July 18, 1985
ST-HL-AE-1298
File No.: G4.2

South Texas Project
Units 1 & 2
Docket Nos. STN 50-498, STN 50-499
Closeout of ICSB Meeting Item Regarding
Auxiliary Feedwater Turbine Control

Marked-up FSAR Text
Auxiliary Feedwater Turbine Control

Insert I

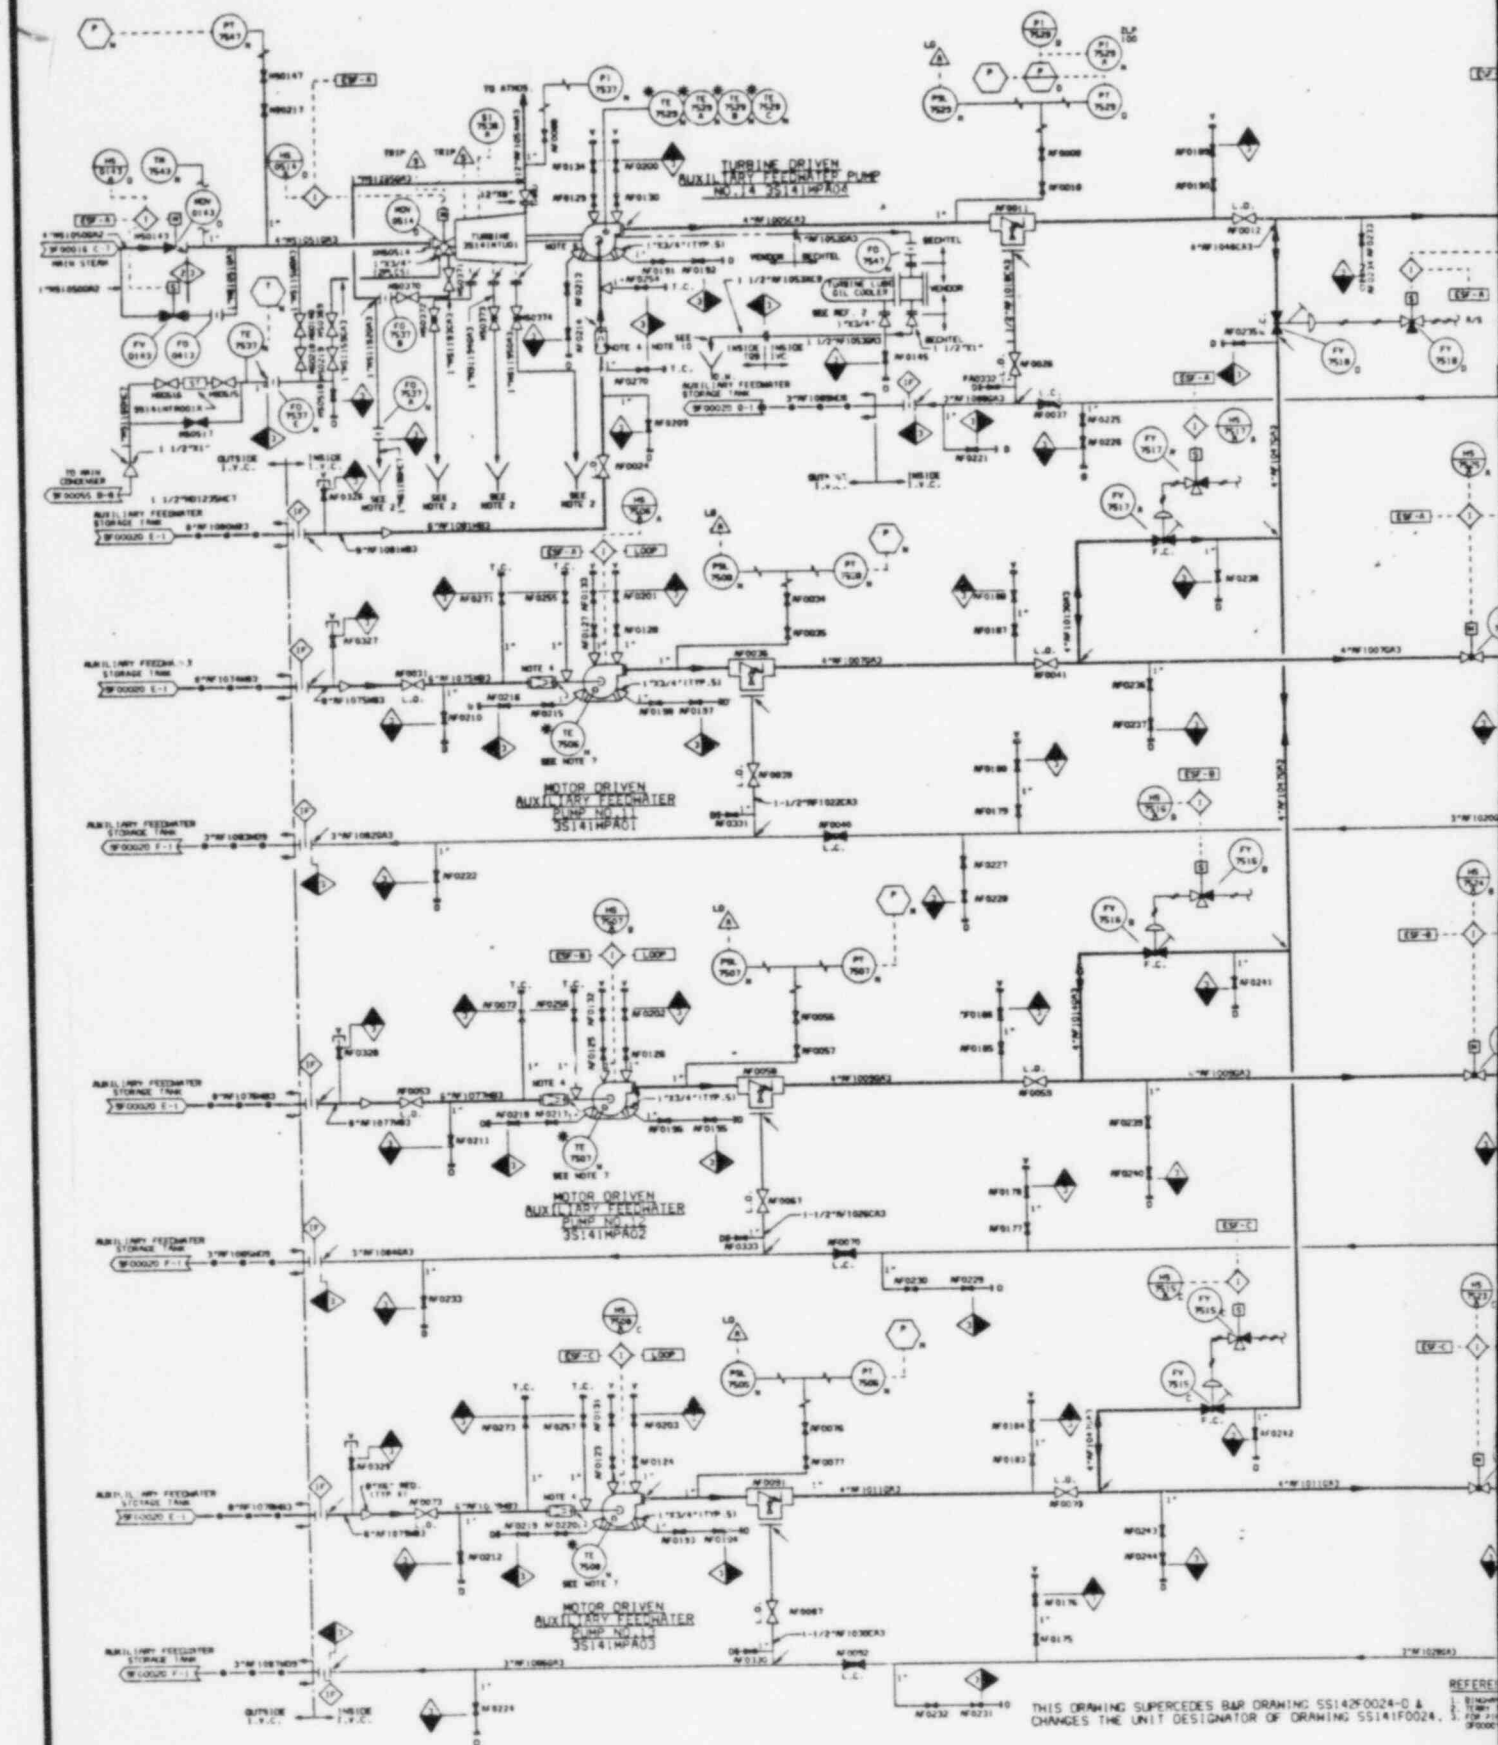
After the steam inlet bypass valve opens, steam flows to the AFW pump turbine through the bypass orifice at a limited flowrate to permit the turbine to accelerate to a speed at which the governor can assume control. After a time delay sufficient for the turbine governor to assume speed control, the steam inlet valve is opened and the turbine is allowed to accelerate to normal operating speed. The turbine trip & throttle valve, supplied with the pump turbine, is a normally open valve. It receives a confirmatory open signal (SG low-low water level in any SG or an SI signal) and may be manually controlled from the control room or the auxiliary shutdown panel.

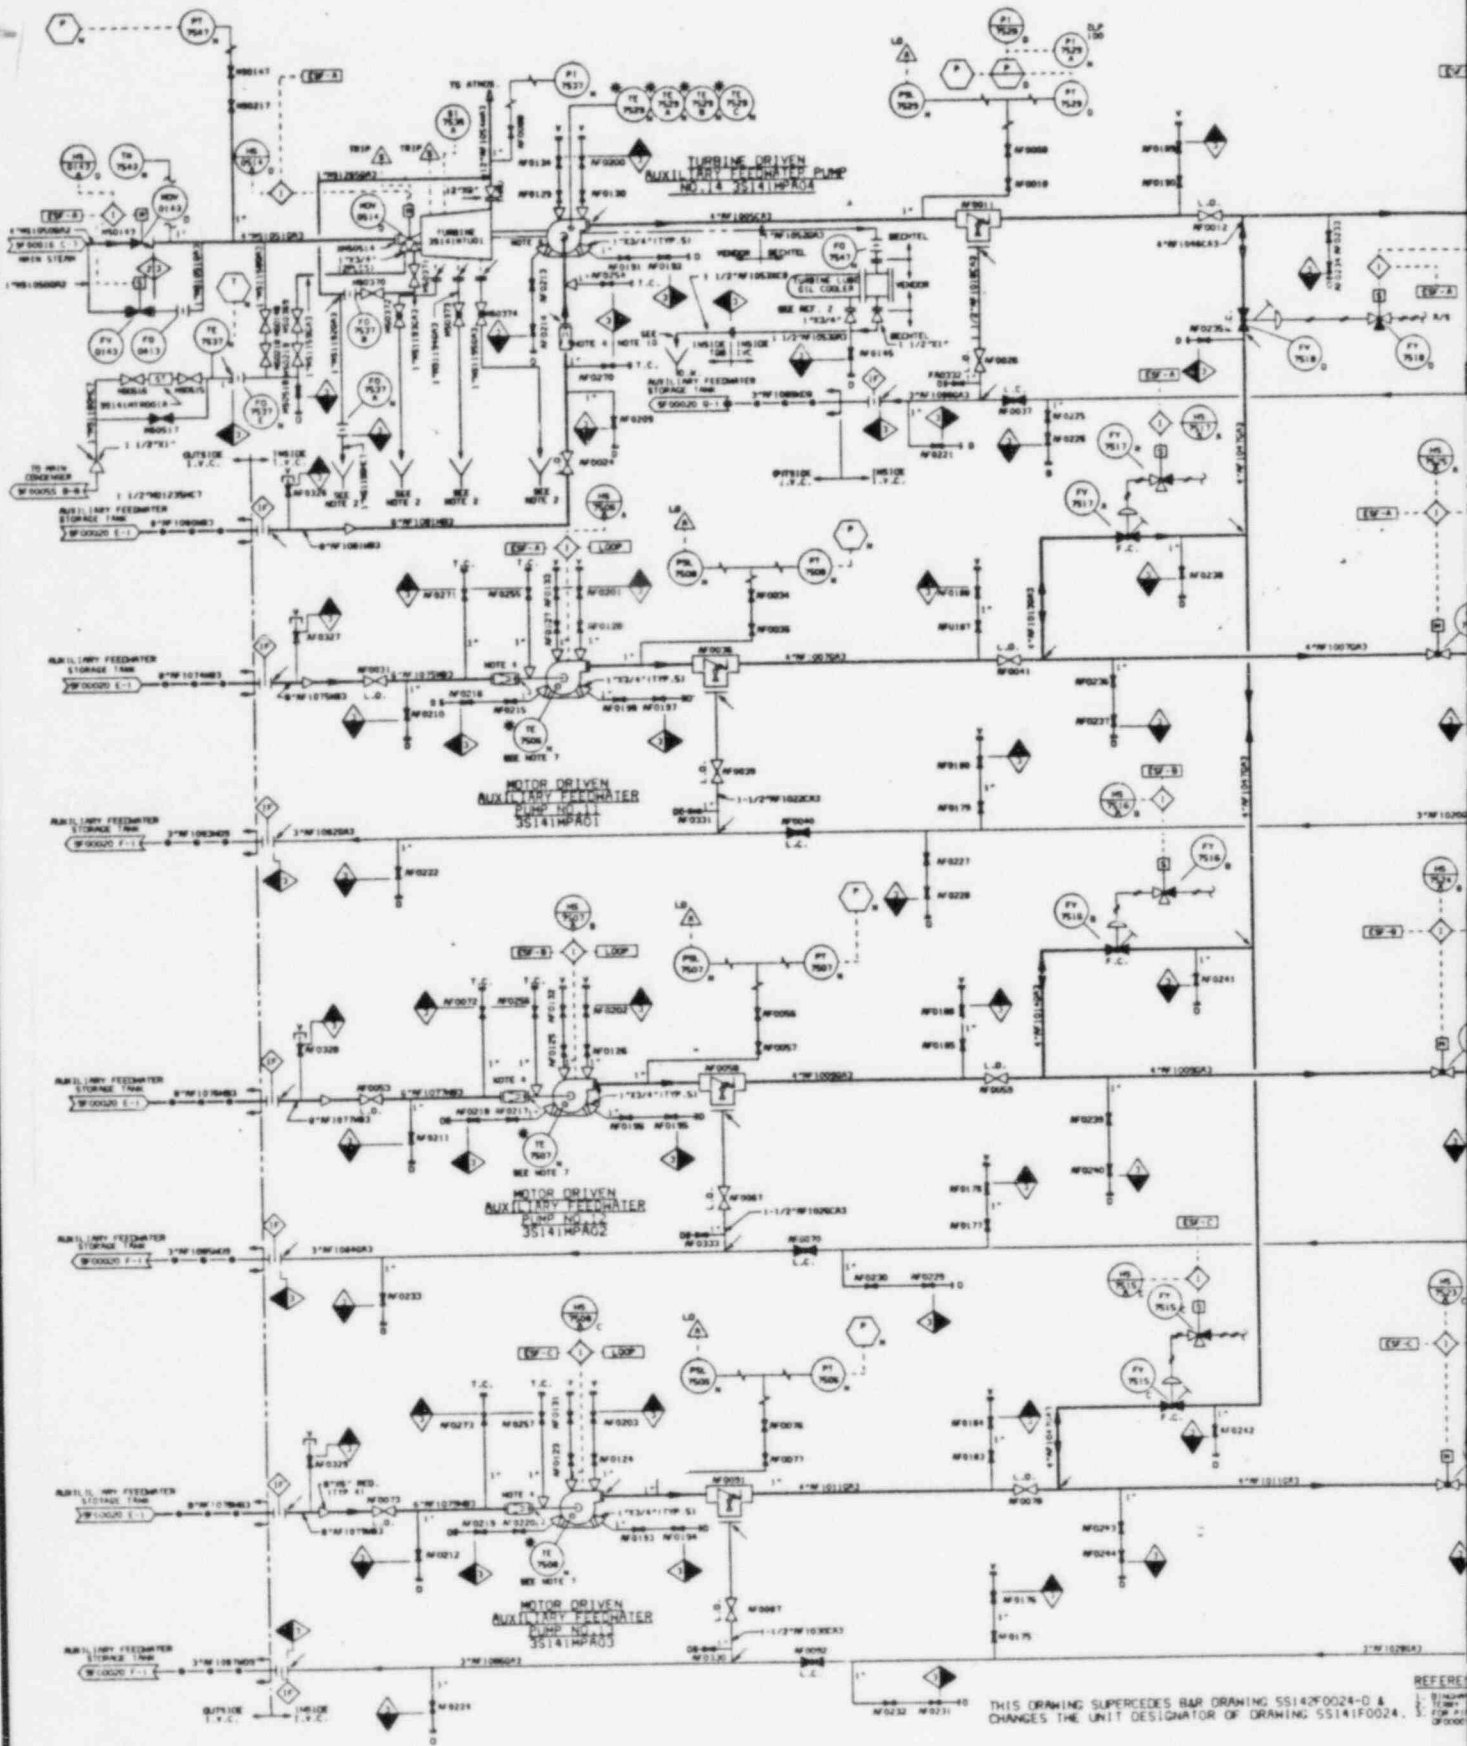
THIS DRAWING SUPERCEDES BAR DRAWING SS142F0024-D & CHANGES THE UNIT DESIGNATOR OF DRAWING SS141F0024.

Figure 6.2.4-1

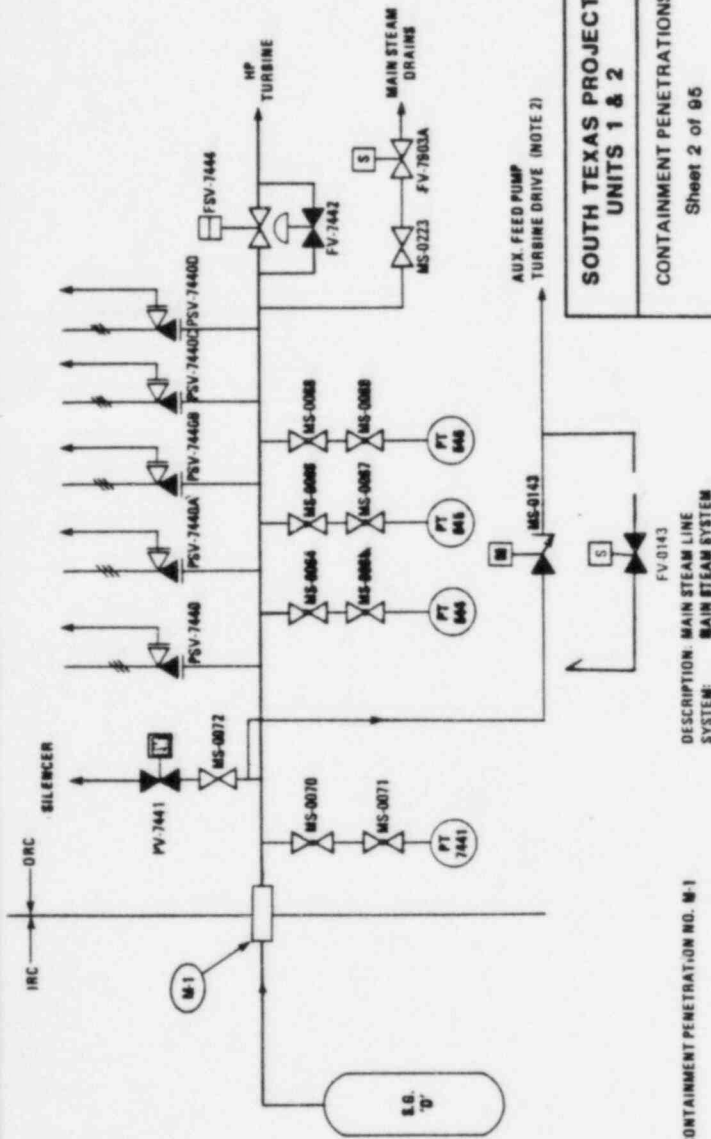
FV 0143	1	OUTSIDE	OUT	GLOBE	SOLENOID	ELEC (D)	AUTO	RM	N/A	CLOSED	OPEN	OPEN	CLOSED	D

NOTE 2: THE MAIN STEAM SUPPLY TO THE TURBINE DRIVEN AFM PUMP IS ESSENTIAL.
